To: T10 Technical Committee
 From: Rob Elliott, Compaq Computer Corporation (Robert.Elliott@compaq.com)
 Date: 18-19 January 2001
 Subject: Minutes of the SRP WG – January 18-19, 2001 – Lake Buena Vista, FL

John Lohmeyer opened the SCSI over RDMA protocol meeting at 1:15 pm Thursday 18 January 2001 and thanked Adaptec for hosting. This protocol standard maps SCSI over InfiniBand™ Architecture, Virtual Interface (VI) Architecture, and similar transports supporting RDMA (remote direct memory access).

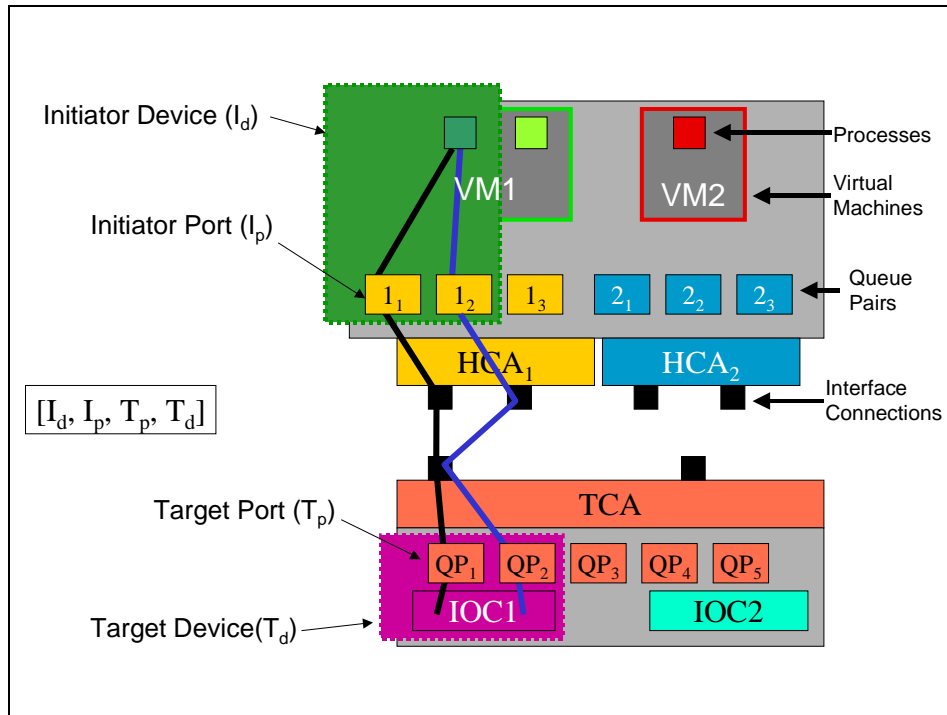
Cris Simpson provided a picture with processes, virtual machines, and queue pairs, showing the location of initiator port, initiator device, target port, and target device. This picture will be added to the annex to help future discussions.
